SUBJECT : PARTS SUPPLY OF THE CONNECTOR FOR TS-850S

SERVICE TECHNICAL REPORT

MODEL TS-850 Series DATE Aug. 08 '91

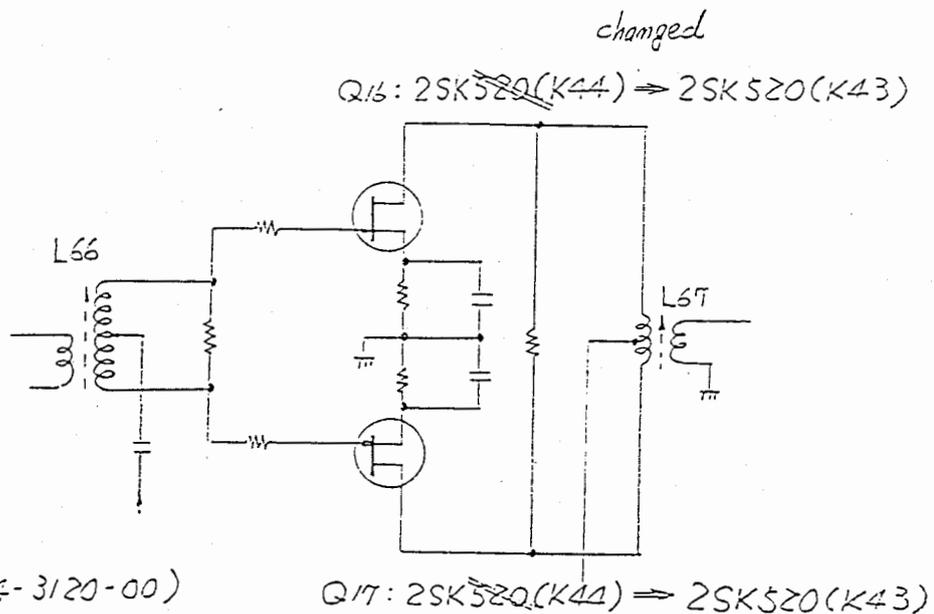
SUBJECT: Change 2SK520(K44) to 2SK520(K43); the mixer FET(Q16, Q17) of the RF unit.

Cause: Variation of Q16 and Q17 gain in the second mixer (73.05MHz to 8.83MHz) FET in the RF unit.

Counter- : Replace the Q16 and Q17 with low IDSS types in the RF unit (X44-3120-00)
measure Q16, Q17: 2SK520 (K44) → 2SK520 (K43) Changed

Circuit diagram: RF unit (X44-3120-00)

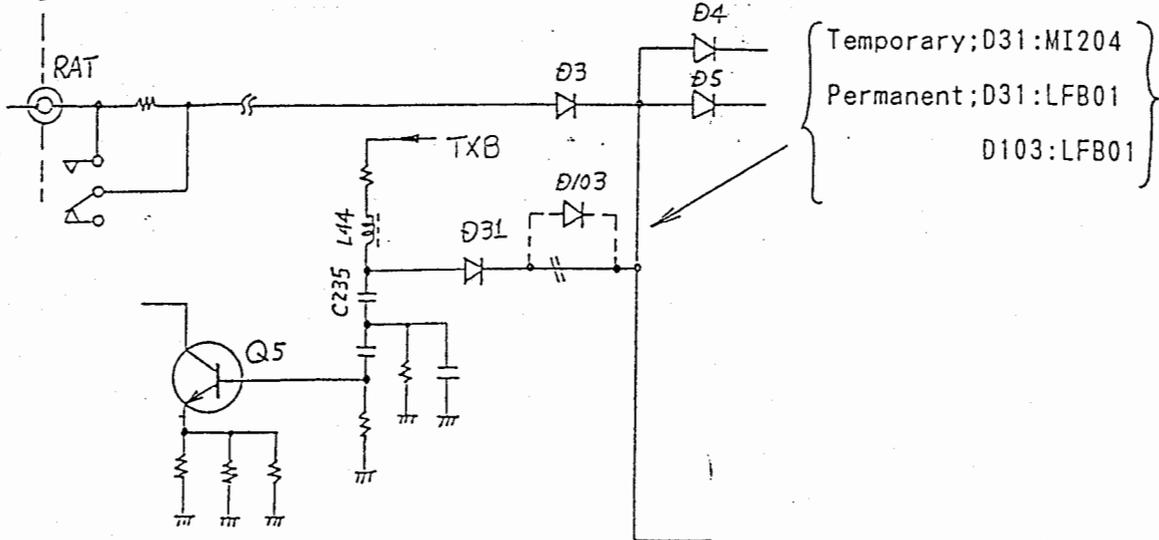
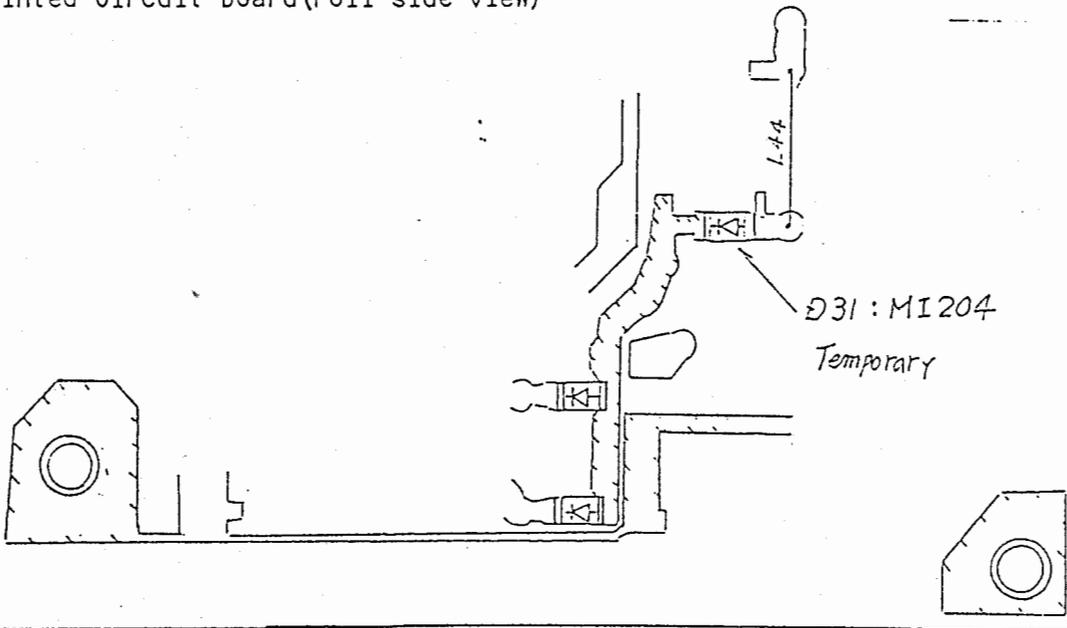
SUBJECT: Countermeasure against defective RF unit D31:RLS135 (due to destruction by electrostatic surge).

Note: In the permanent countermeasure, the pattern is changed, with D31 and D103 connected in series.

RF unit (X44-3120 -xx)
Address E-5 in circuit diagram.

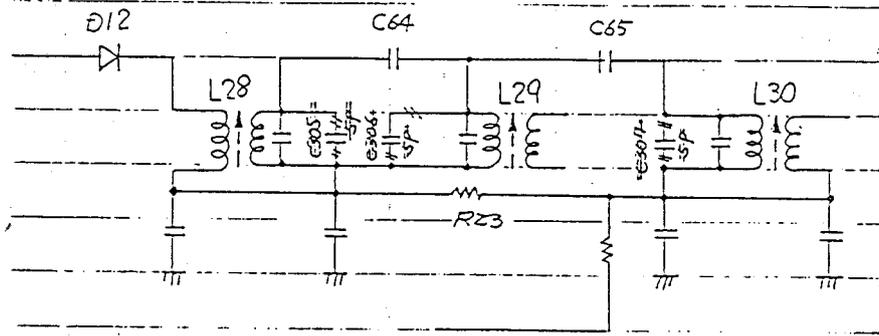
SUBJECT Removal of matching capacitors in association with use of new parts. (removal of capacitors C305 to C307: 5 pF for L28,29 and 30 from RF unit)

The ceramic capacitors, C305 to C307: 5 pF (CC45CH1H050C), were added to solve the problem of a failure to tune B.P.F. due to a matching capacitors connected to the tuning coils.

New tuning coils have a built-in 5 pF capacitor and so do not require C305 to C307.

Remove ceramic capacitor C305 ~ C307 (5 pF)

RF unit (X44-3120-XX)
 (Foil side view) PC Board
 address T-2,3

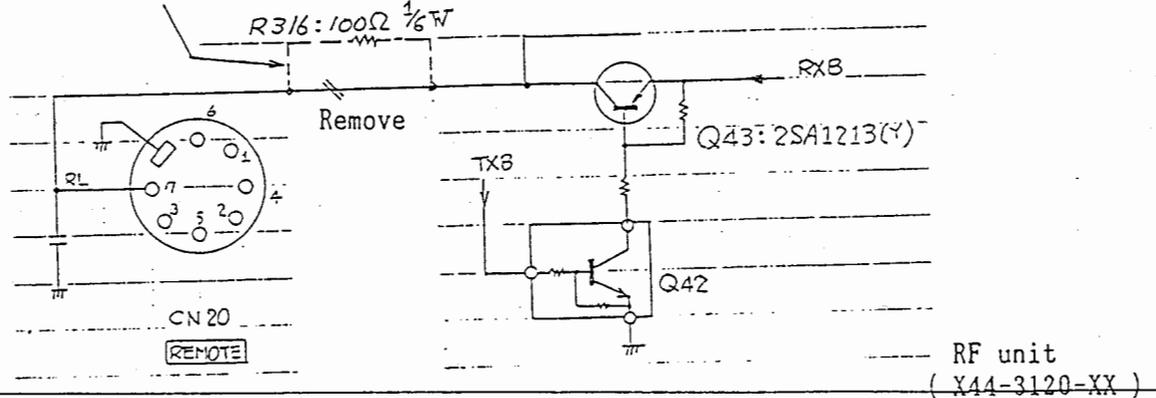
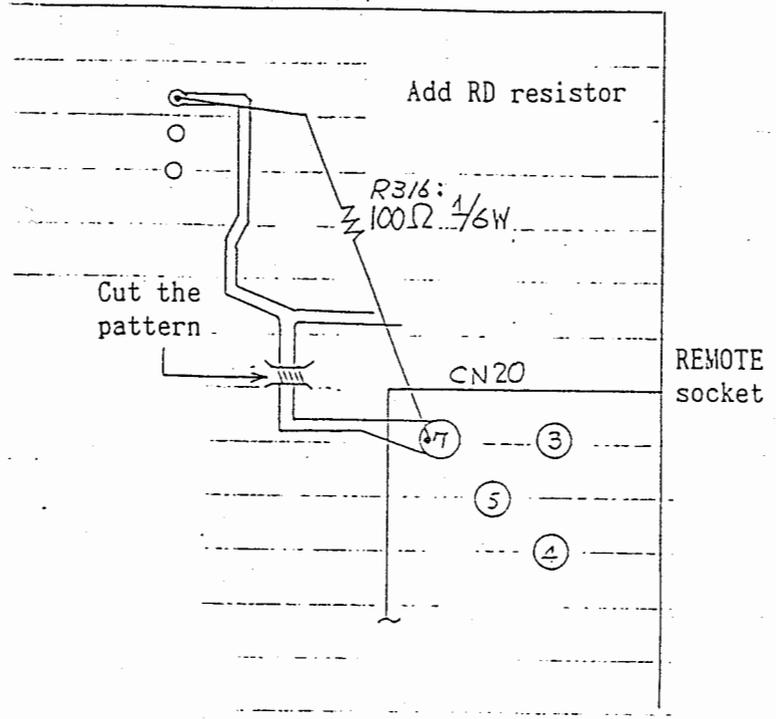
Cause : Pin 7 (RL line) is directly connected to Q43:2SA1213(Y) (TXB-RL DC SW Tr) on the RF unit. If pin 7 (RL line) of the REMOTE socket is grounded, the emitter and collector of Q43 short circuit in a quick time and consequently defective.

Countermeasure : A protection resistor is installed against the defective of Q43 on the RF unit in case pin 7 of REMOTE socket is grounded.

Carbon resistor 100 Ω : RD14BB2C101J 1/6 W
Resistor to be added.

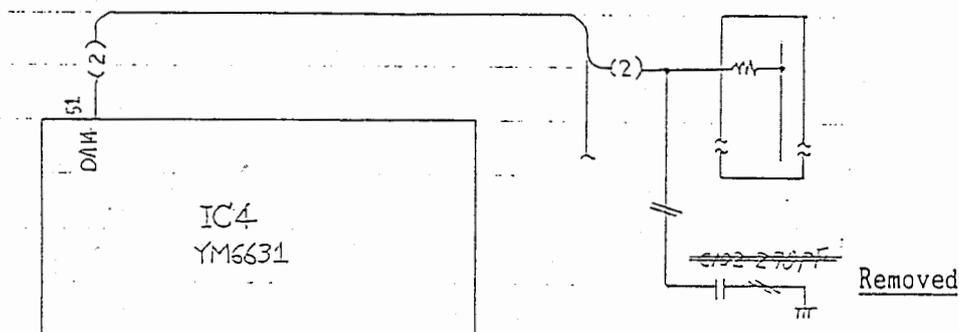
Cause : The capacitor C102: 270pF, was installed by mistake. This pacitor connects to the DDS IC in the CAR unit (X50-3140-00). (The circuit diagram shows that the capacitor connects between IC 4 pin 51 and GND. Actually, however, it was connected between IC pin 52 and GND on the PC Board.

Countermeasure:
The chip capacitor C102: 270pF, will be removed from the CAR unit (X50-3140-00).

Note: The C102: 270pF, has located on the component side of PC Board (it is on the upper-left corner of IC 4: PC Board address: B-6.) Removing this C102 improves the level of DDS produced spurious radiation from -60dBm to -75dBm, so there is no more beat at all. The improvement is from 3.5 mV to 1.5mV rms.

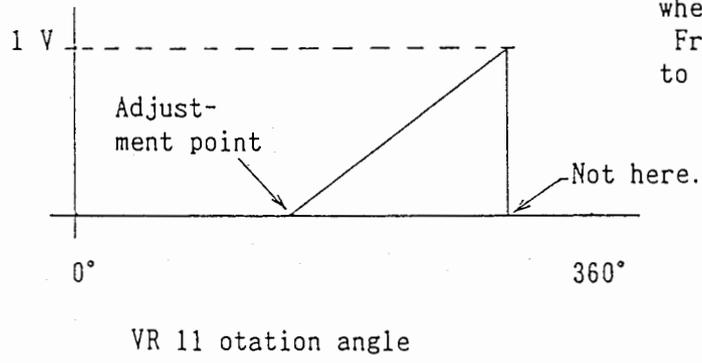
Cause : ALC meter misadjustment (RF unit : VR 11). VR 11, which is an endless semi-fixed variable resistor, is adjusted to the point that has no carbon (no resistance value).
To match the meter indication, the gain of the meter amplifier must be at the maximum. Then, the meter amplifier output exceeds the input range of the A/D converter.

Counter-measure : The adjustment procedure of the ALC meter (Item 34, on page 105 of the Service Manual) will be changed as follows :

Method	Rated value
At present : RF unit VR 11	Adjust immediately before the voltage indicator moves.	0 V
After change : RF unit VR 11	Turn the VR 11 clockwise at around the 1 V range to lower the voltage until the point where no change is observed. From that point, fine-adjust to the starting point.	Approx. 10 mV

CAR unit
(X50-3140-00)

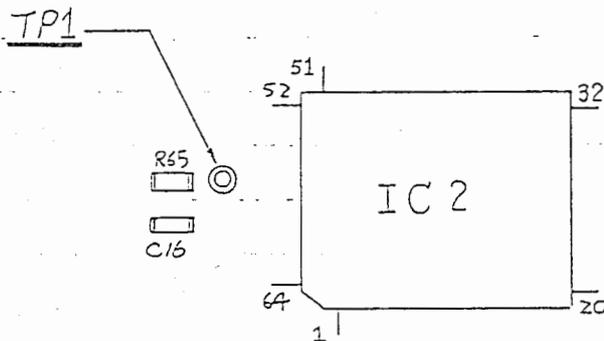
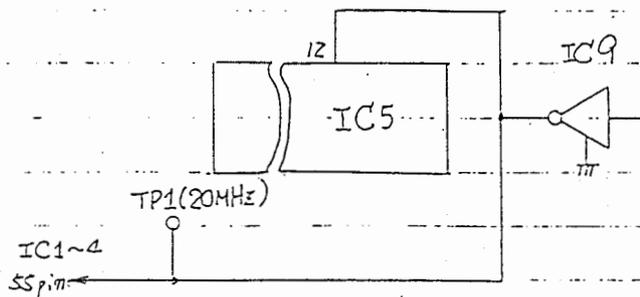
Background : The adjustment point of the 20 MHz Ref. OSC, which used to be in the PLL unit, had low oscillation level and showed incorrect display on the connected frequency counter.

So the adjustment point (TP 1 terminal) is moved to the CAR unit side on which the 20 MHz Ref. OSC, has a increase oscillation level; address B-3 (on the left side of the IC 2) on page 161 of the printed circuit board diagram of the Service Manual. (Also, the TP 1 terminal is not found in the circuit diagram address F-3 in-between the IC 5 pin 12 and IC1-4 pin 55).

Circuit diagram address: F-3

Printed circuit board
component side view address: B-3

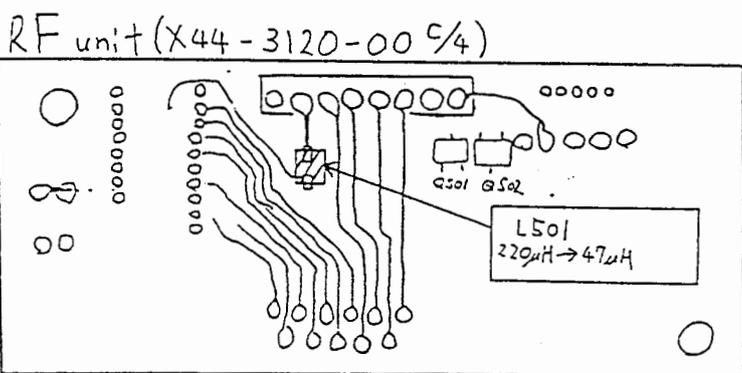
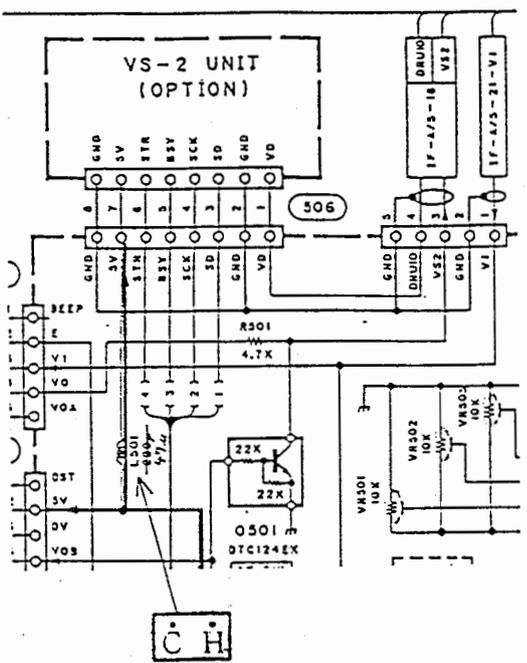
Phenomenon: VS-2 Can not talk with TS-850 but depends on a Combination.

Countermeasure: RF unit (X44-3120-00 C/4) L501 change from 220 μ H to 47 μ H.

FINAL UNIT (X45-1470-00)

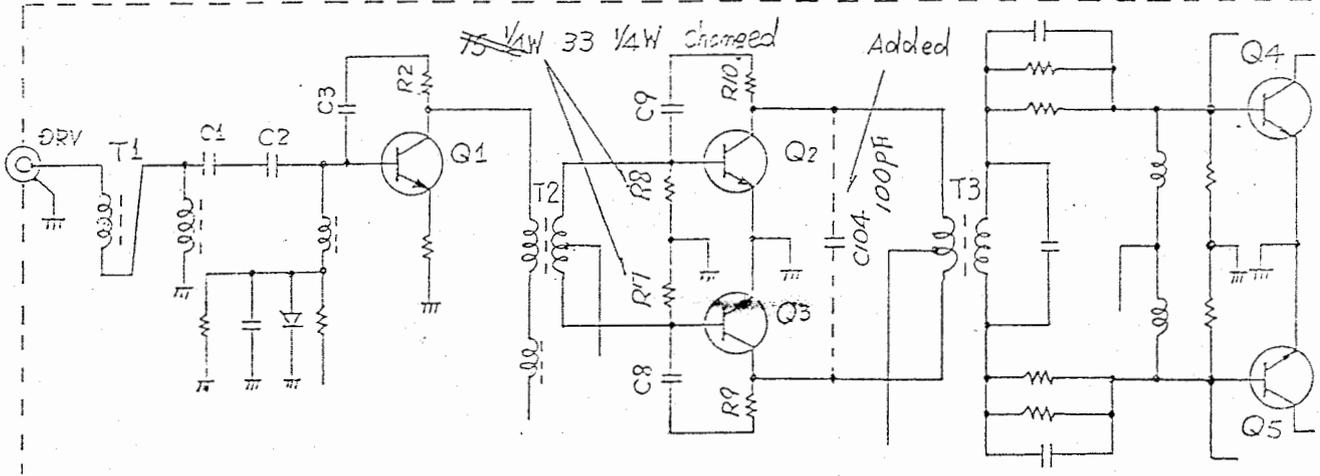
SUBJECT: Part change due to production discontinuation of drive transistors Q2, Q3: 2SC2509 (2SC2509 → 2SC3133).

- 1) Transistors Q2, Q3 (2SC2509) → → 2SC3133 Changed
- 2) Carbon resistors R7, R8, 15-ohm, 1/4W → → 33-ohm, 1/4W (RD14CB2E330J) Changed
- 3) Ceramic capacitor C104, 100pF (CC45SL2H101J)* Added

*: C104 (100pF) will be soldered on the T3 input side. Holes for this are provided in the Printed board (between R10 and T3).

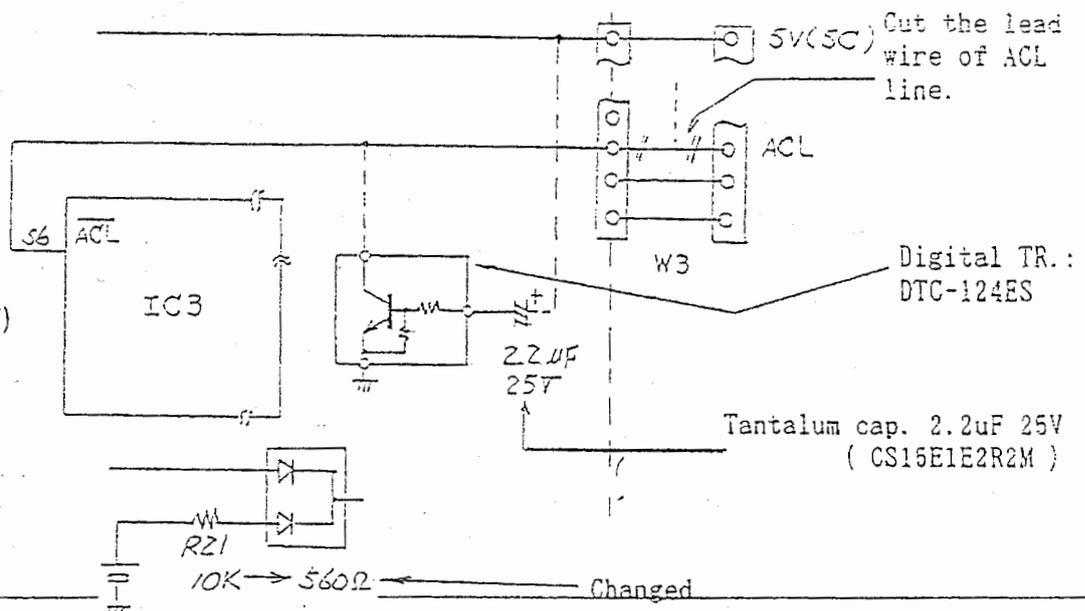
Cause: The lithium battery that back up data in the TS-850 containing the DRU-2 has dried up. When the TS-850 power switch is turned off, the lithium battery in the DRU-2 backs up recorded data, but it dries up much earlier because more than 100uA backup current flows (as compared to normal current of 1-2uA).
 When the DRU-2 is kept in storage by itself, the backup current is normal. Only when the DRU-2 is installed the TS-850 does the trouble occur.
 When power to the TS-850 is turned off with the DRU-2 connected to the TS-850, excessive backup current flows from the DRU-2's ACL line to the TS-850's reset line.

- Counter-measure : 1) Add a digital transistor DTC-124ES and tantalum capacitor 2.2uF 25V: CS15E1E2R2M to the ACL line of the DRU-2 unit.
 2) Change part of the circuit to accommodate the addition of 1).
 R21:10K →→1.2KΩ (RK73FB2A122J) Changed
 3) Cut the lead wire of ACL line at the connector W3.

Digital TR: DTC124ES

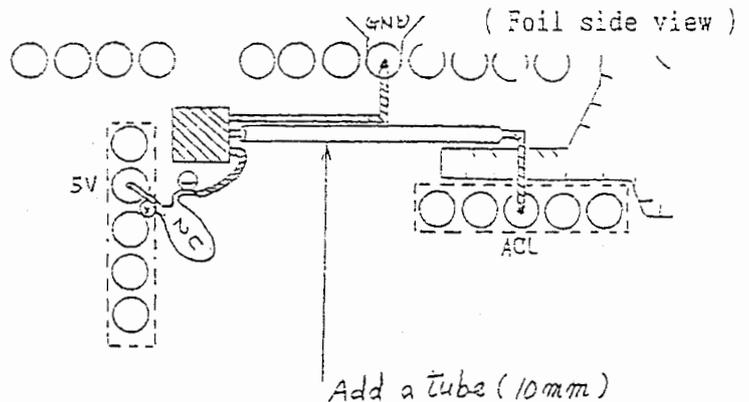
- 1) Replace the lithium battery (W09-0326-05) and insulator to the lithium battery. (Upper and lower side)
 Note: Lithium battery replacement is not required if the DRU-2 is in storage by itself.
- 2) Add a digital transistor DTC-124ES and tantalum capacitor 2.2uF 25V: (CS15E1E2R2M) to the ACL line of the DRU-2 unit.
 Note: Add a *tube* to digital transistor DTC-124ES of collector lead.
- 3) Cut the lead wire of ACL line at the connector W3.

R21
10K → 560Ω
